Notice of Meeting of the Historic and Architectural Review Commission of the City of Georgetown, Texas July 23, 2026

1.C 1202 Laurel Street, (2026-33-COA)

Public hearing and possible action on a request for a Certificate of Appropriateness (COA) for a new building construction and a new fence, railing or wall that is inconsistent with the overlay district's characteristics and applicable guidelines, for the property located at 1202 Laurel Street, bearing the legal description of Laurel Place, Lot 1&2, 0.909 Acres (2026-33-COA) -- Madelyn Allen, Planner

Re: 1202 Laurel Street LOT 1, follow-up from 7/9 Conceptual Review

Plans and Specifications - Elevations

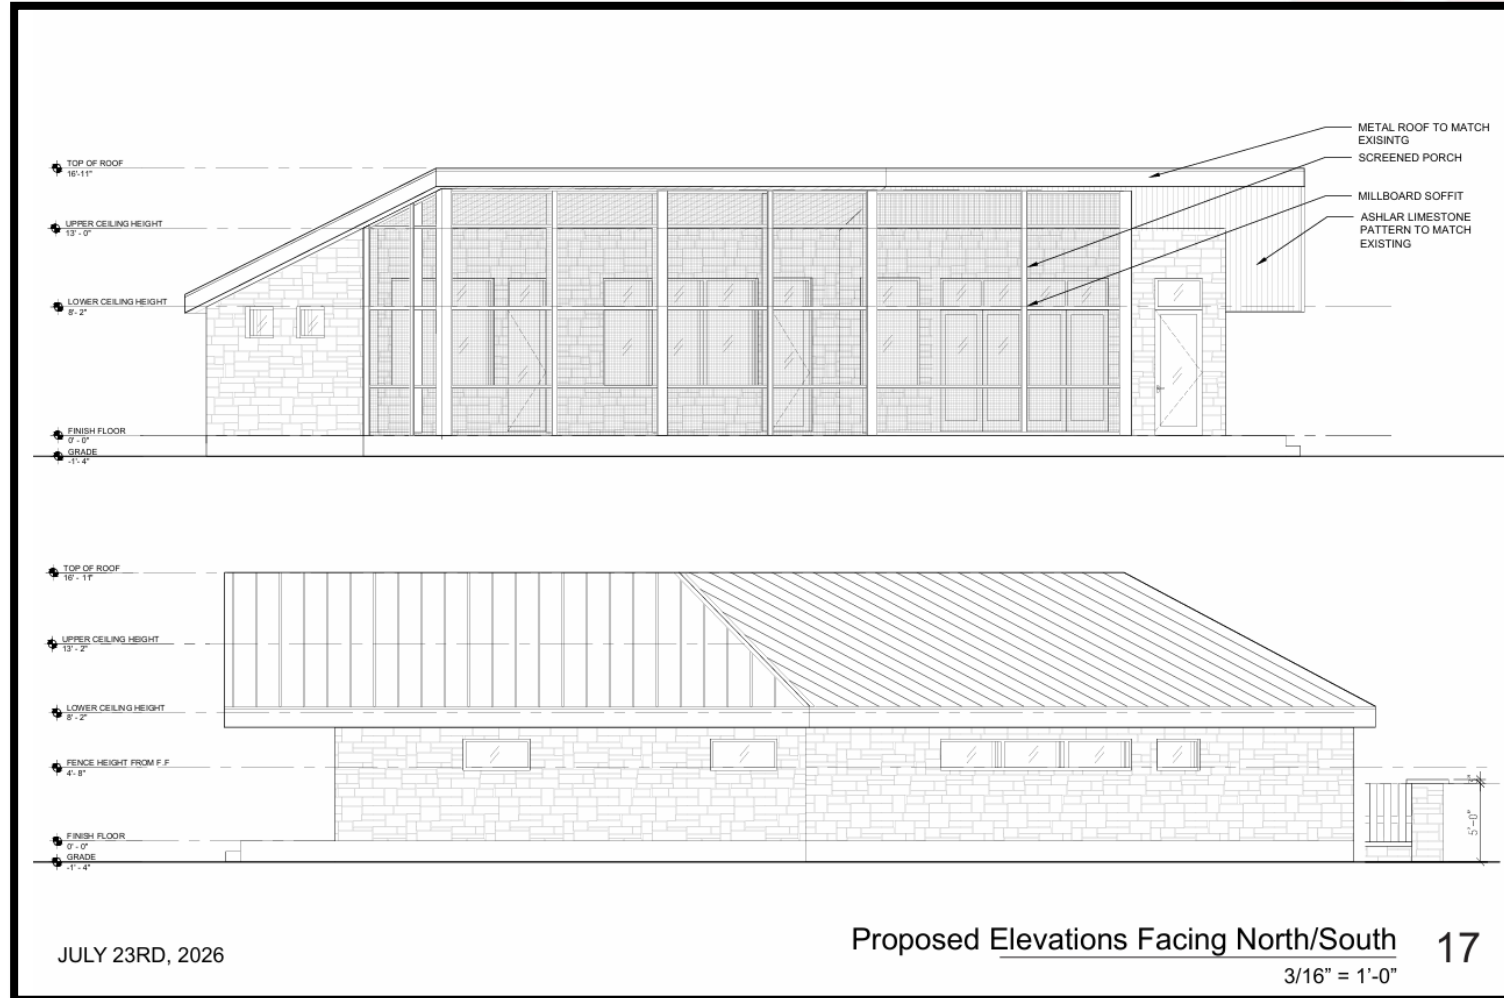
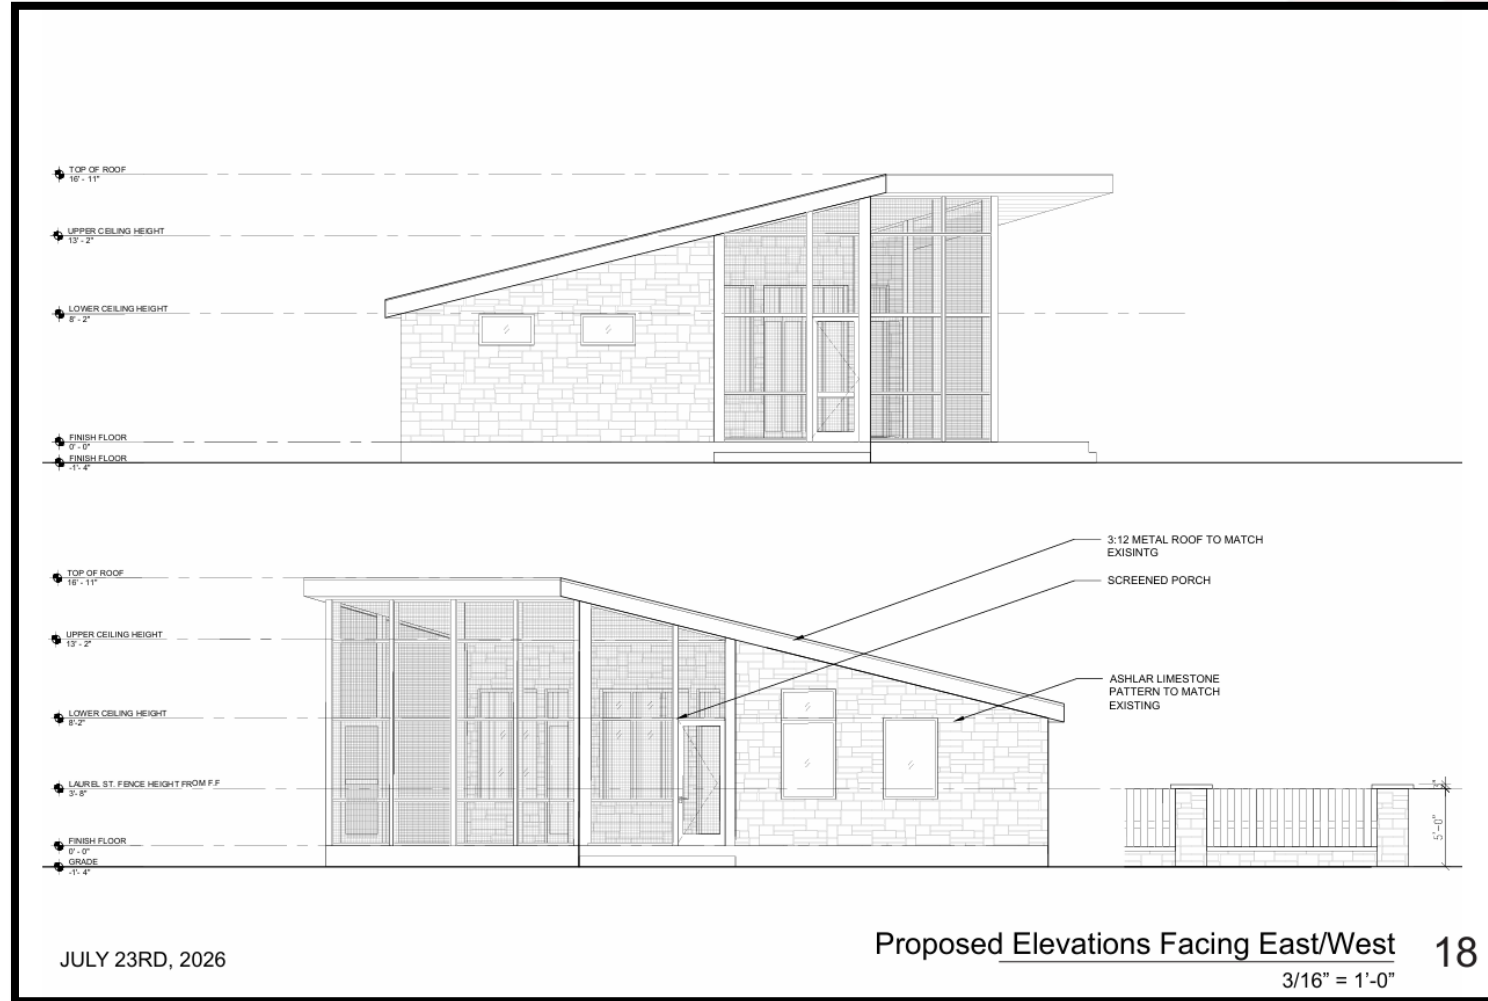
a. The main mass form should be a simple square, a rectangle or an "L-Plan" with an uncomplicated roof form, that is having a minimum of roof plane changes.	Partially Complies The main mass is in an "Open-V" form, but the roof form is uncomplicated.

In response to City comment regarding guideline 3.5.F.4, the minimum depth of the front porch has been increased from 4 feet to 6 feet.

Alt. Roof Form, University / Laurel St. Facade Elevation

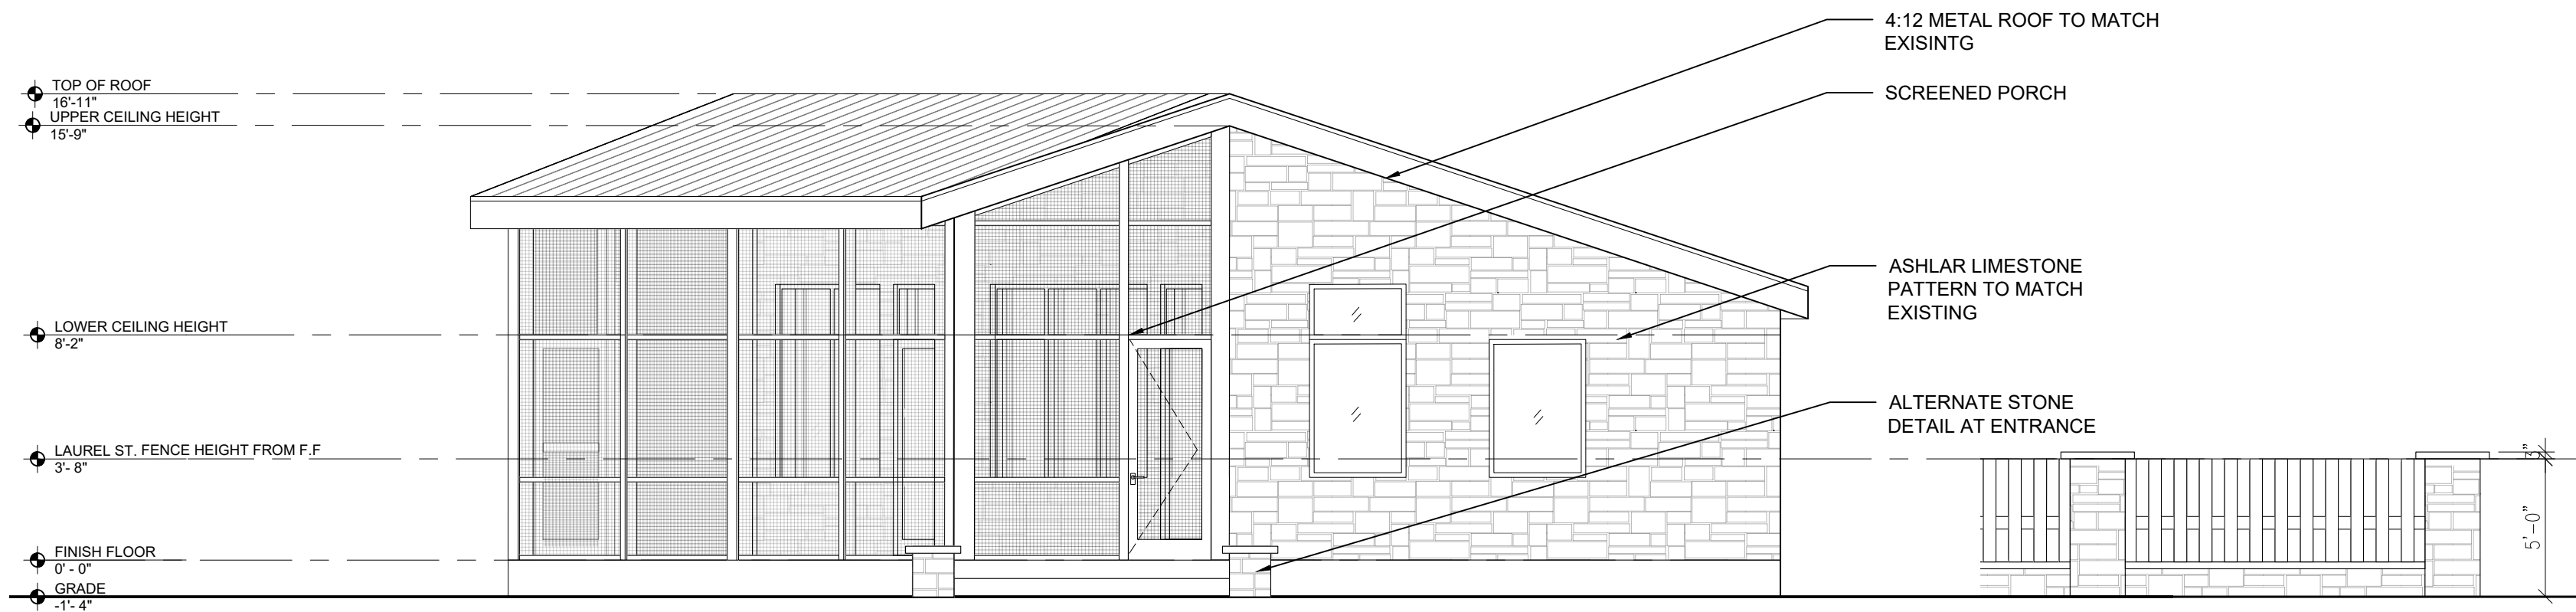
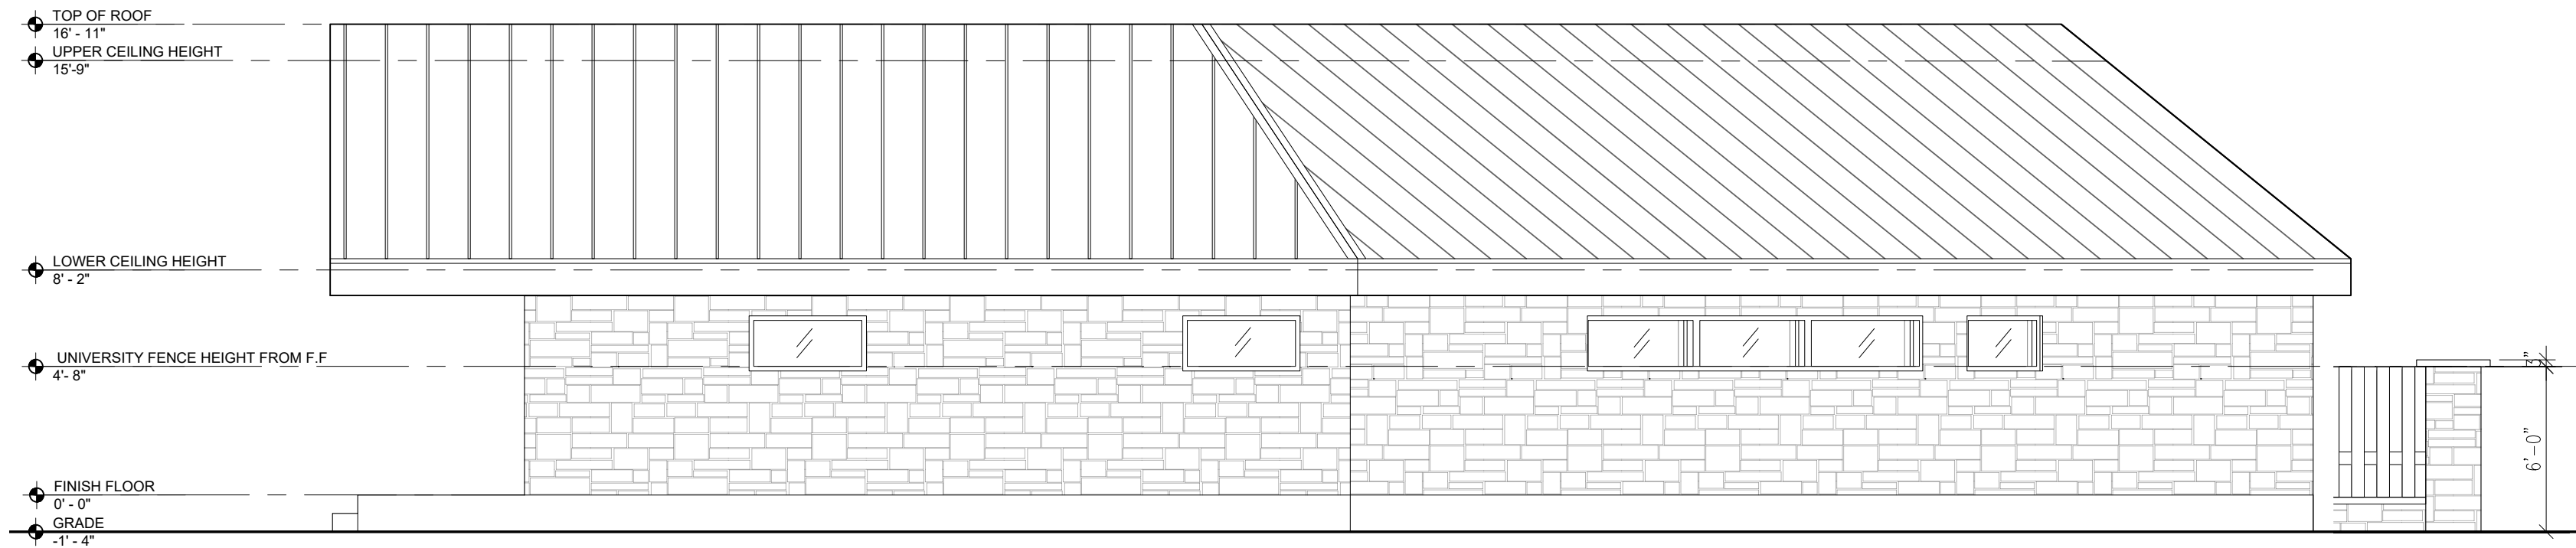
However, in response to the Commission's comments during the Conceptual Review, we have also developed an alternate design utilizing a gable roof. This gable roof allows the structure to be more "freestanding" apart from the adjoining property, even though they are adjoined per above. While this is not our preferred solution, we are providing this alternative for the Commission's consideration in the case that the proposed shed roof form remains a significant concern in this review process.

1 SOUTH ELEVATION - PROPOSED
OPENINGS
1/4" = 1'-0"

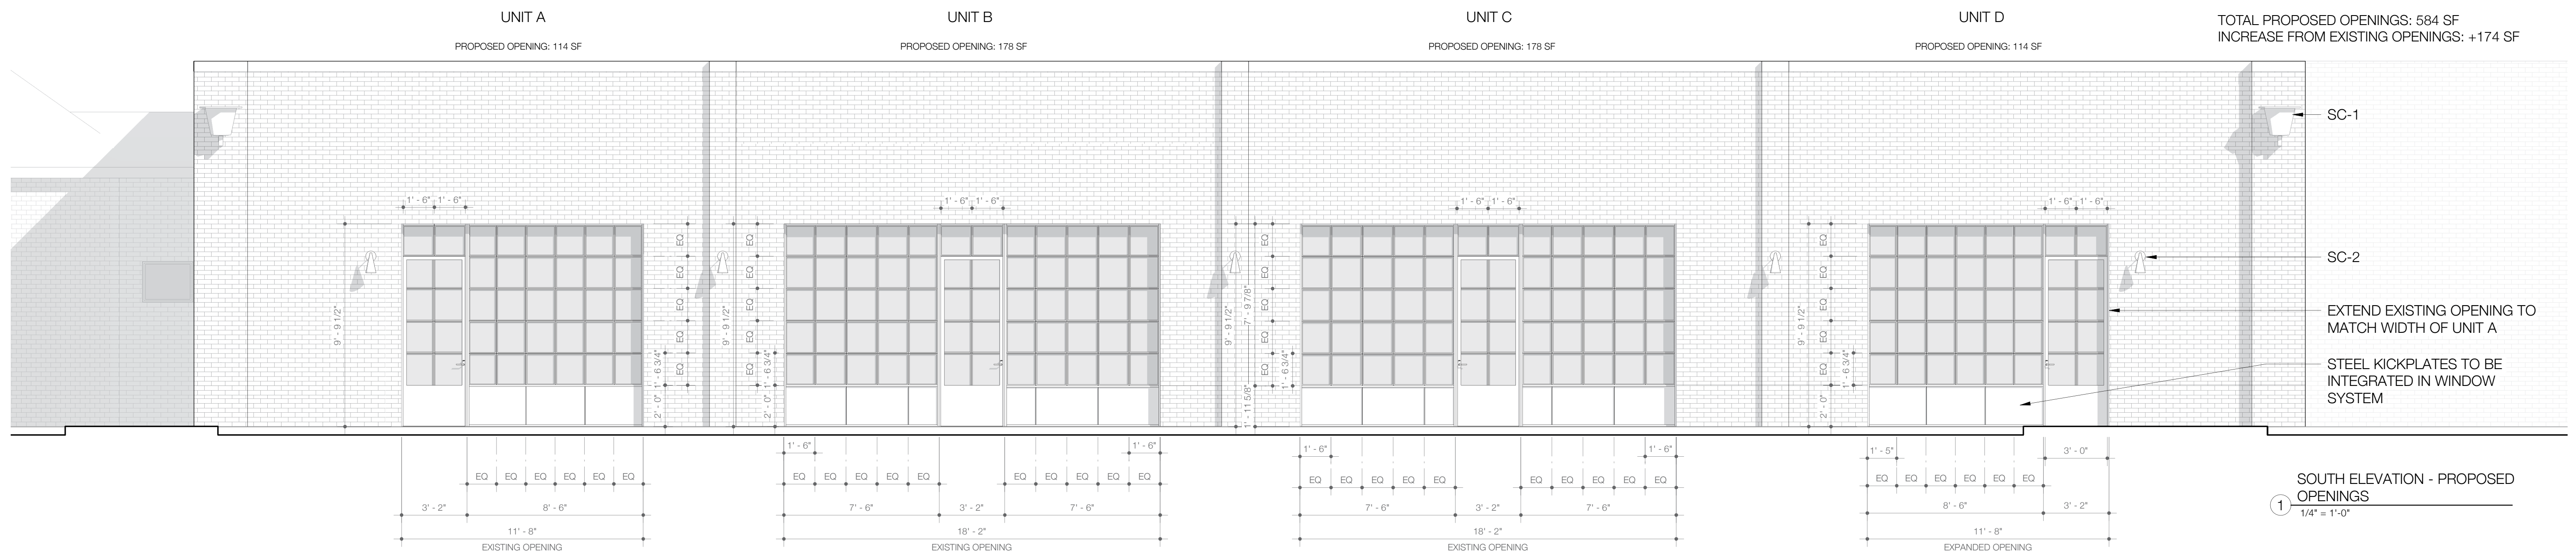
a. The kick plate, located below the display window, adds interesting detail to the street scape and should be preserved.	Partially Complies The proposal introduces a metal kick plate, which does not meet the guidelines for appropriate materials. However, it is compatible with materials historically present on the building and provides additional storefront definition. The original kick plate no longer exists, preventing full restoration of the historic condition.

b. Building entrances should be recessed. Repetition of recessed entries provides a rhythm of shadows along the street, which helps establish a sense of scale. Recessed entries were designed to provide protection from the weather and the repeated rhythm of these shaded areas along the street helps to identify business entrances.	Does Not Comply The proposed entries include only shallow recesses and do not create the depth or rhythm envisioned by the guidelines. Staff recognizes that the building has not historically featured recessed storefront entries, and creating deeper recesses would substantially alter the building's current configuration.

TRANSOM NOTE

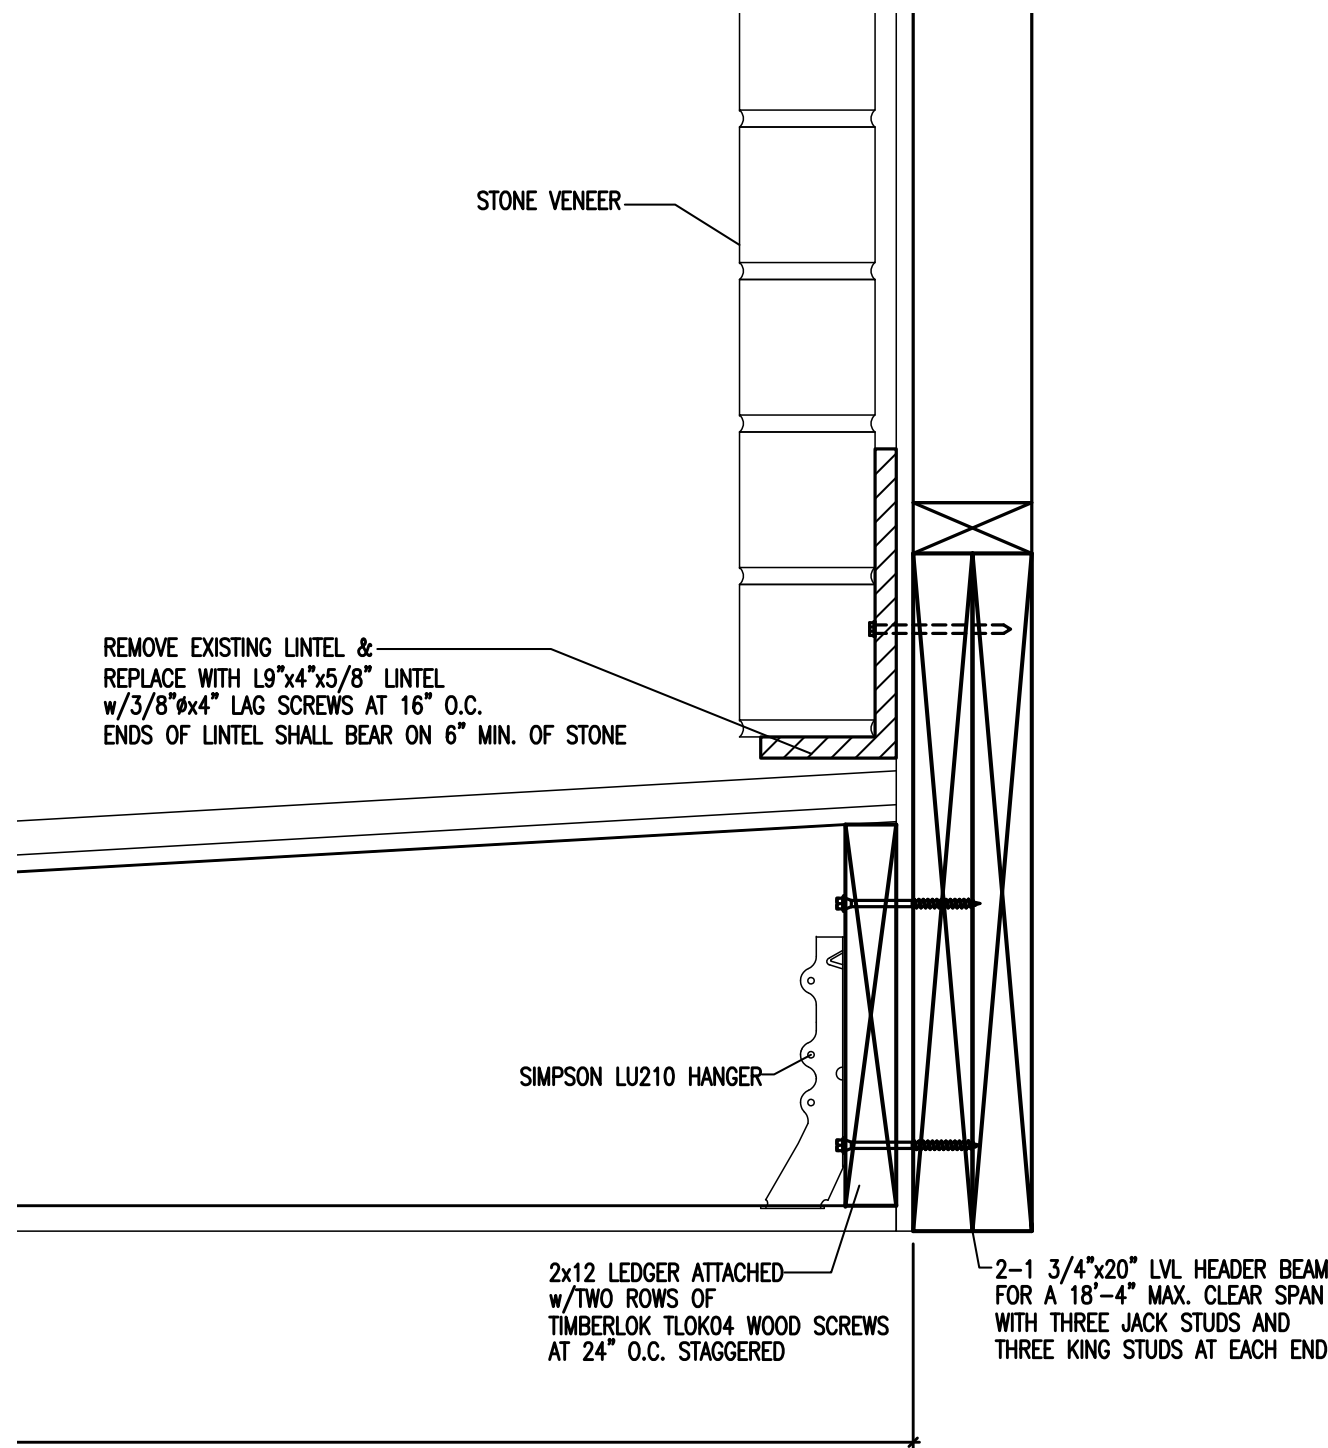
The awning's structural requirements - mounting brackets, tie rods, and support header - occupy the wall area directly above the storefront openings. The clearance remaining between those elements and the existing roof is too shallow to fit a transom of adequate proportion. Any transom forced into that space would appear undersized, out of character with the historic storefront, and too shallow to provide the light or architectural benefit the Guidelines intend.
